March 28, 2022

Re: Mistis Properties Inc, 176 Virginia Road  
Site Plan Response Memo

This Memorandum responds to the outstanding Site Plan comments set forth in the Kellard Sessions Consulting, P.C. Memorandum, dated May 7, 2021. Kellard's comments are provided attached, Our responses are noted below in bold, blue and italics.  
Included here within:

**REINFORCED CONCRETE WALL**  
SCALE: 1/2"=1'-0"

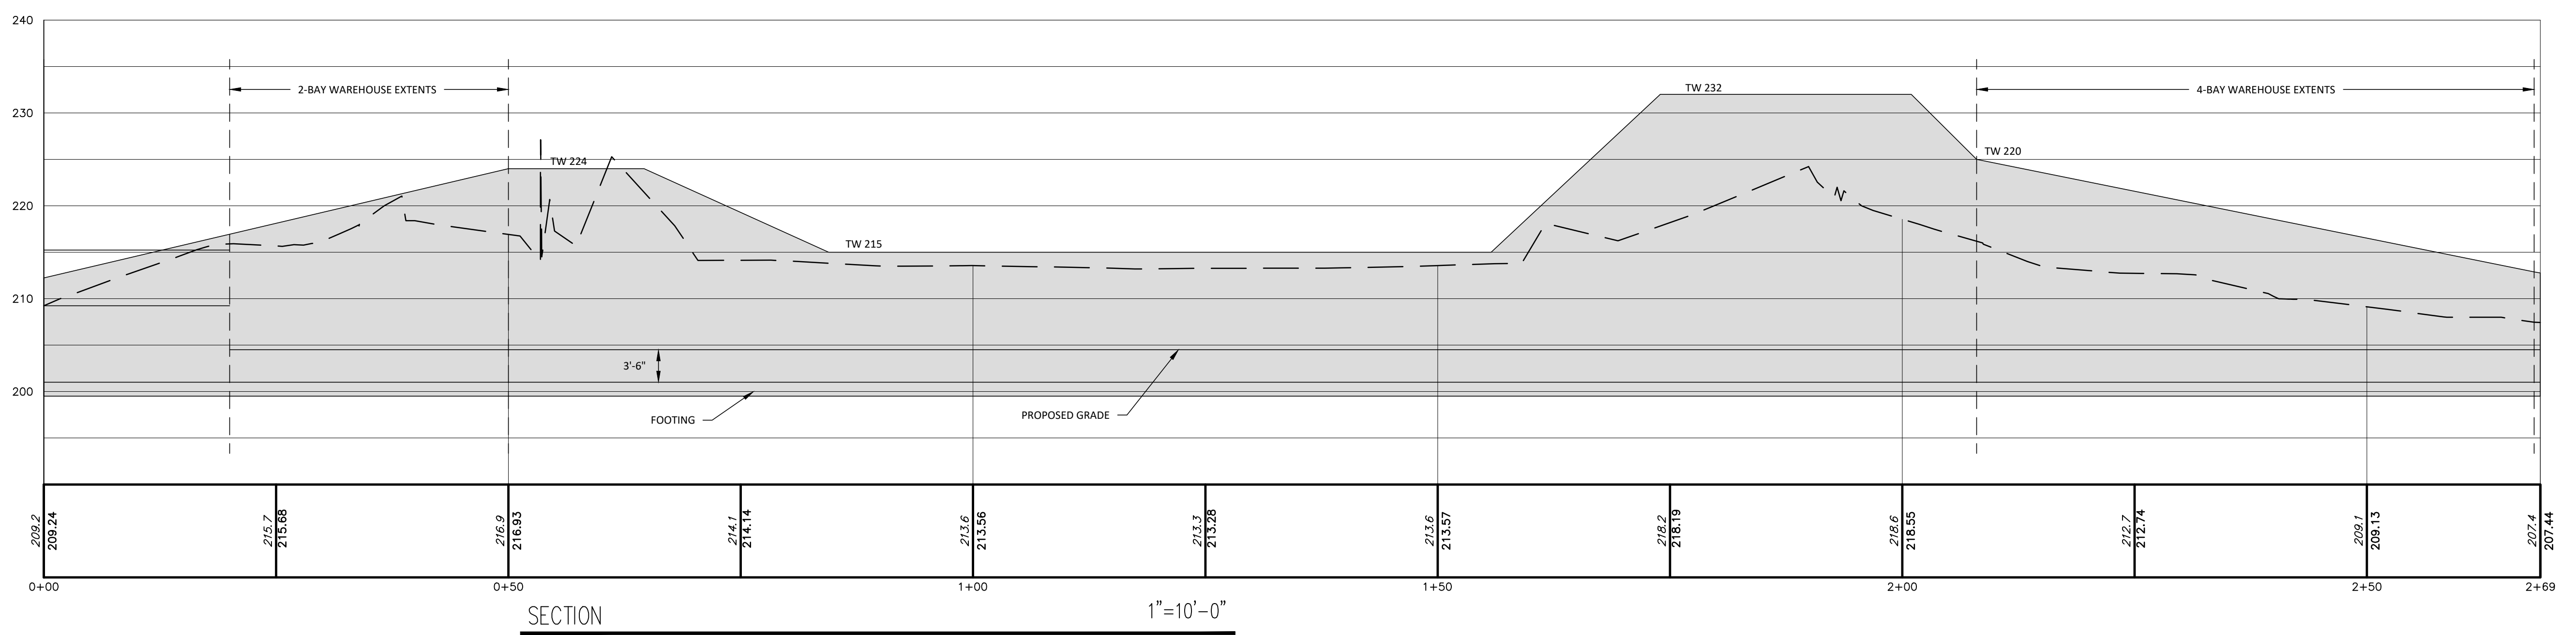
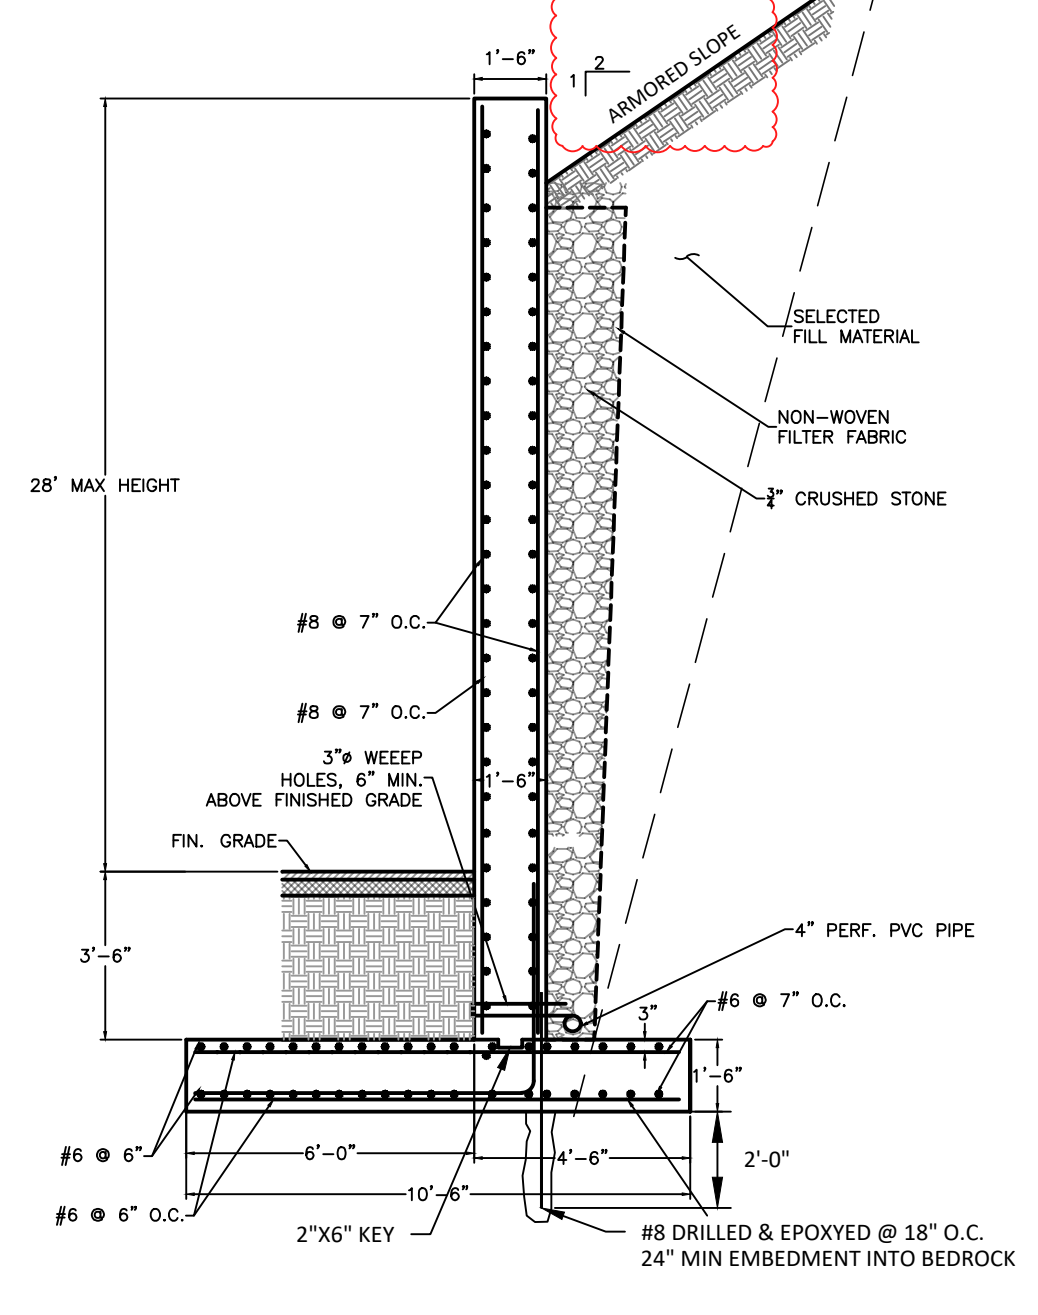
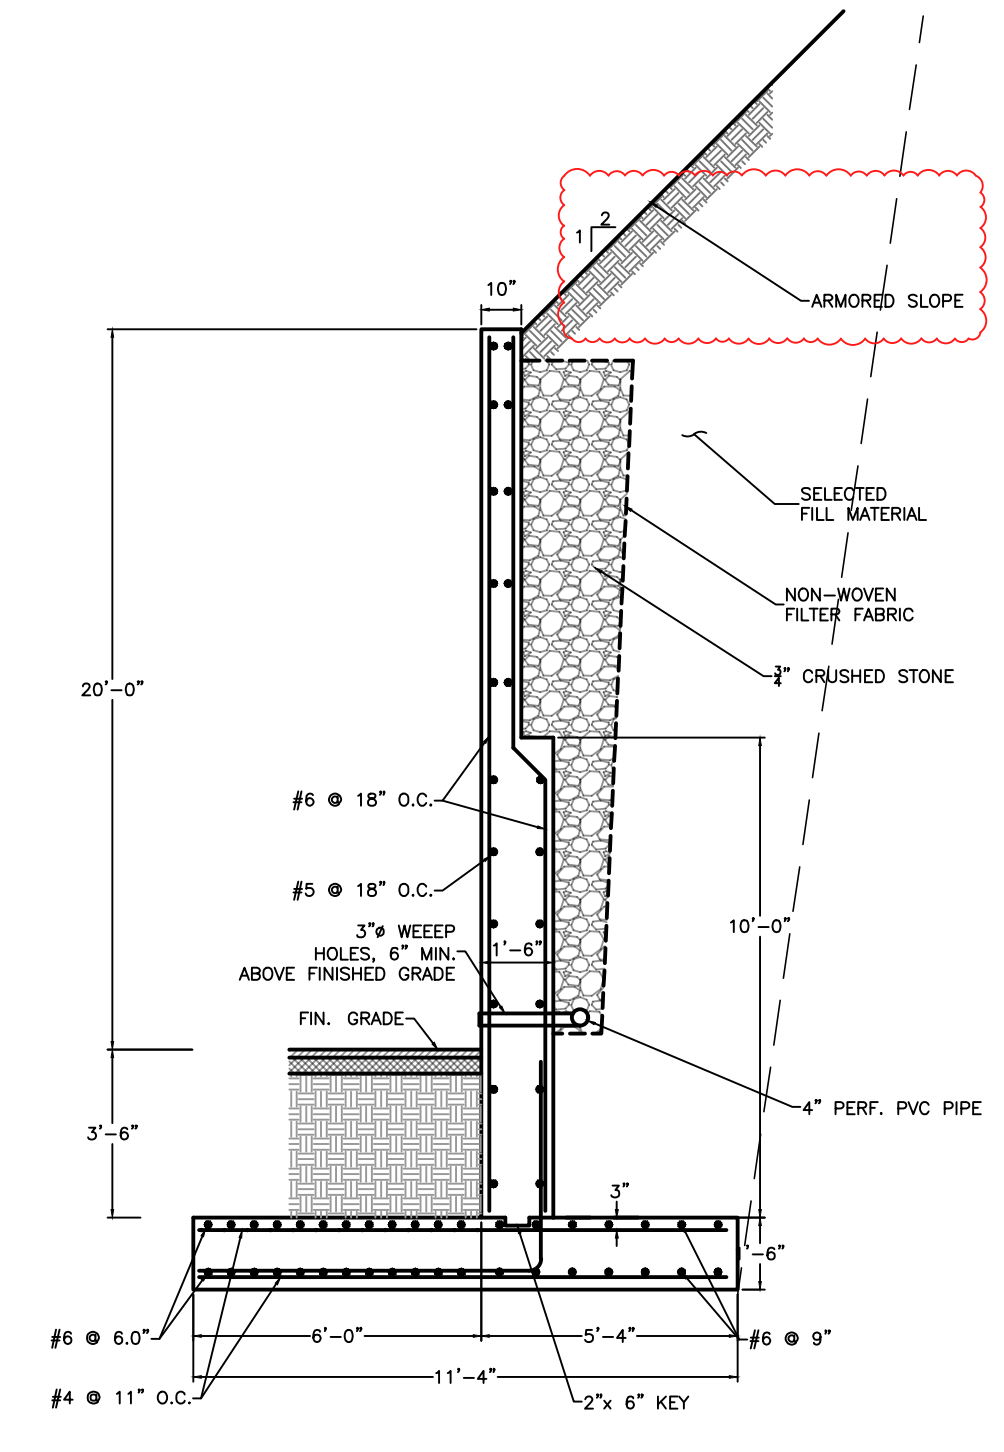
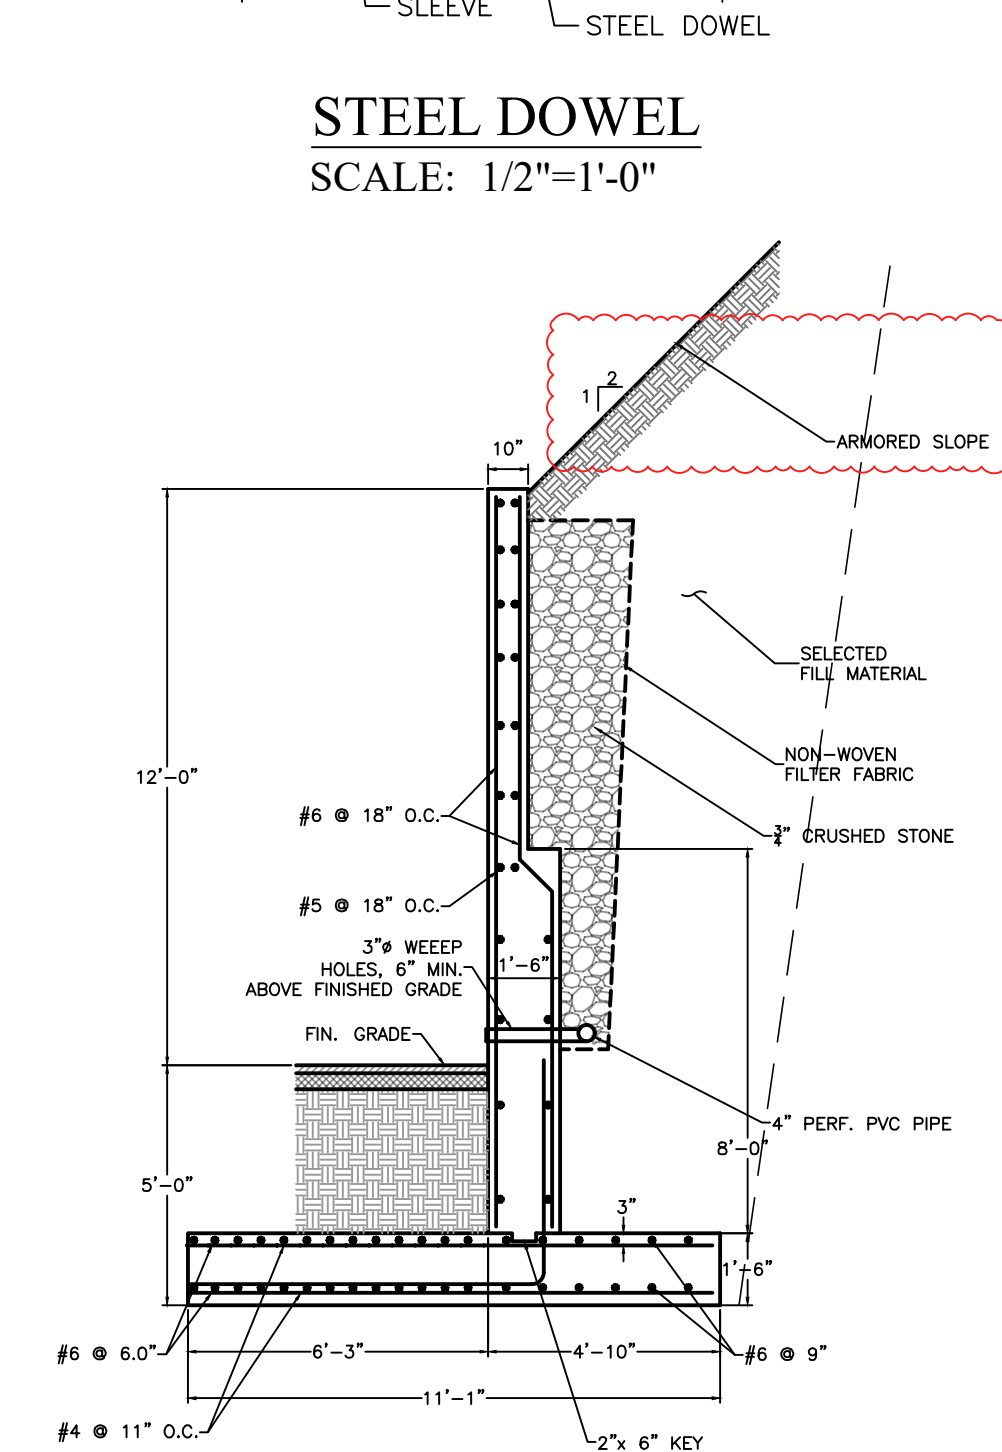
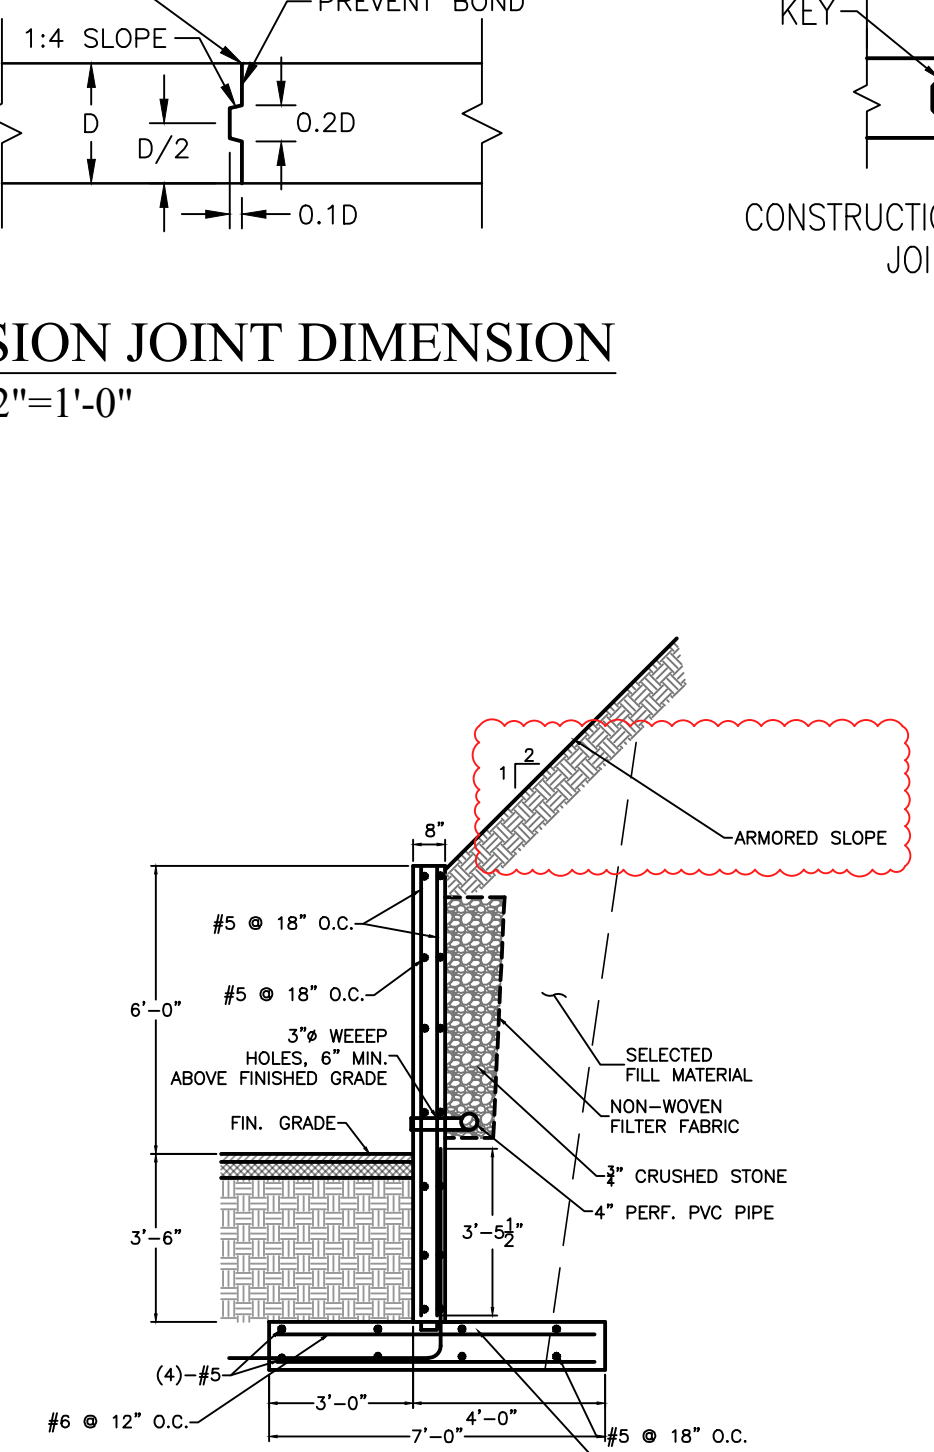
1. The plan requires a retaining wall along the rear and sides of the property with a maximum height of approximately 28 feet. For clarity, the proposed retaining wall shown on the grading plan shall include top of wall and bottom of wall elevations at each change in elevation to be coordinated with the elevation changes shown in section provided on Sheet S-7. The plan shall also illustrate the required grading of the slopes above the retaining wall necessary to maintain the proposed 1V:2H slope and include a detail of the armored slope referenced in the typical retaining wall section.  
*Plans were updated as per comment. (See Retaining Wall Section on Sheet S-7.)*

LIGHTING PLAN

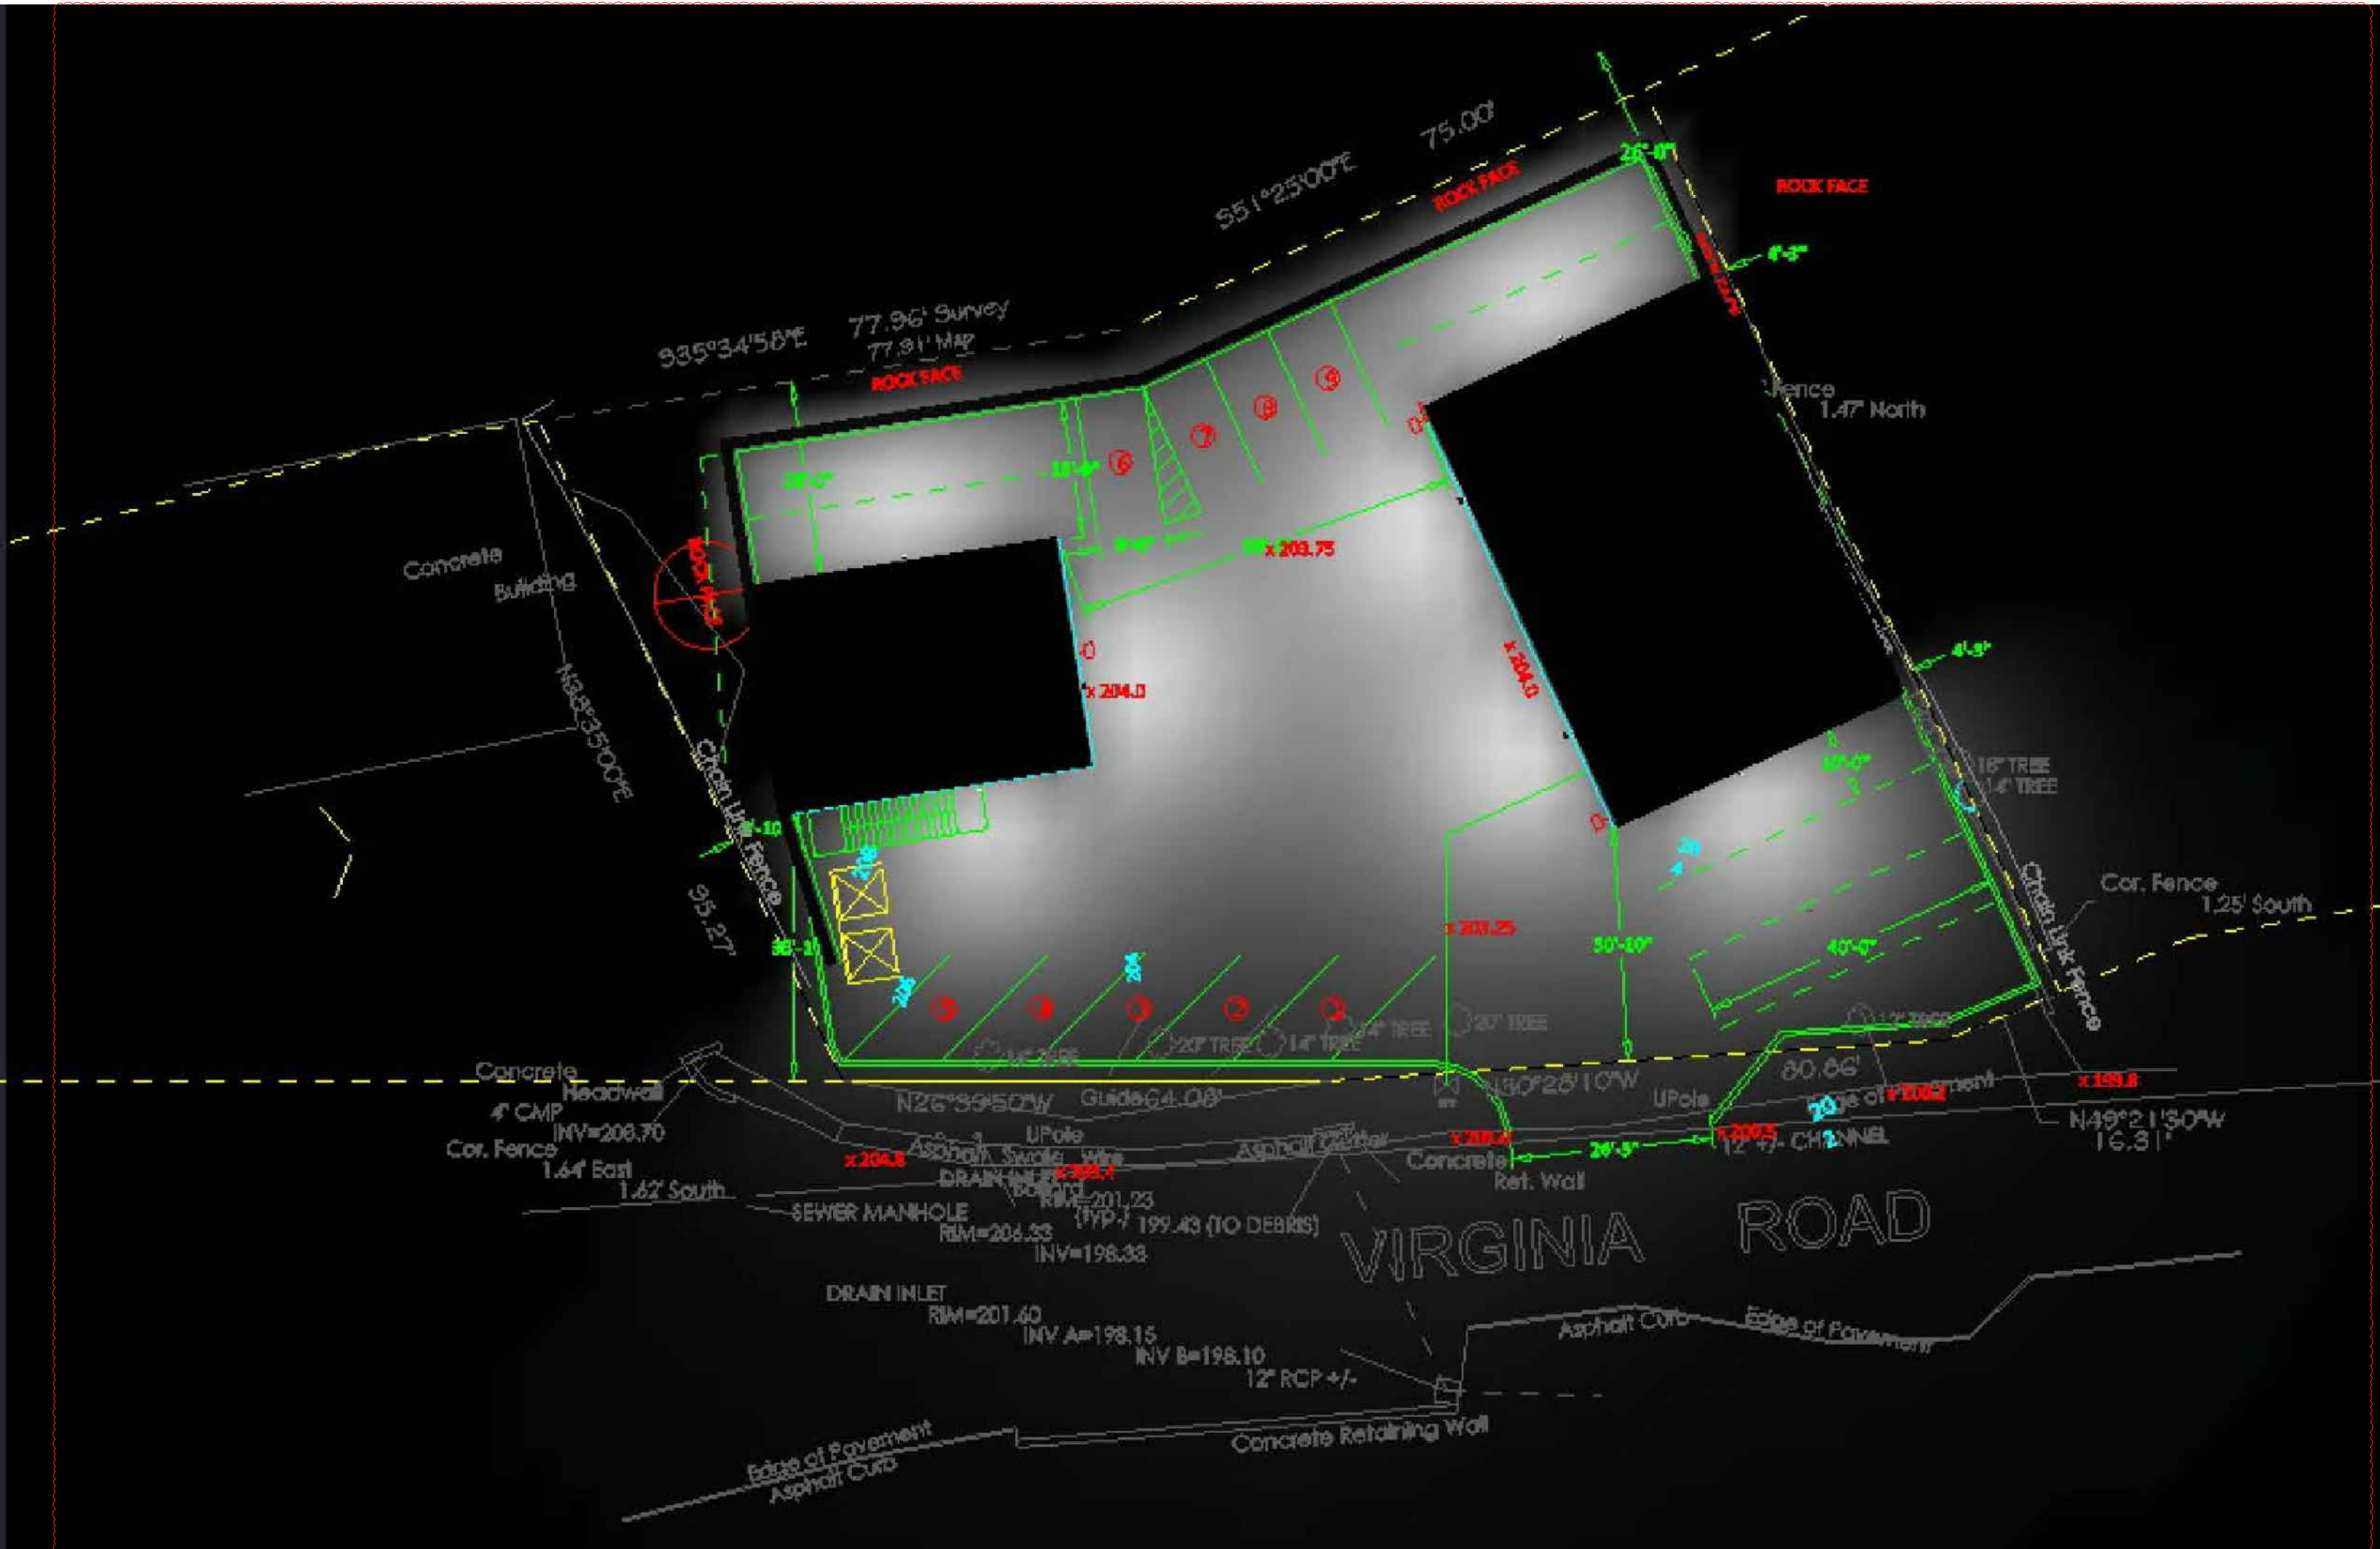
2. Provide a site lighting and photometric plan for review and consideration by the Planning Board include specifications and details of all fixtures, poles, and pole bases.  
*Plans were updated as per comment. (See Site Lighting & Photometric Plans, Schedules, Specifications and Detail on Sheet E-1 to E-3.)*
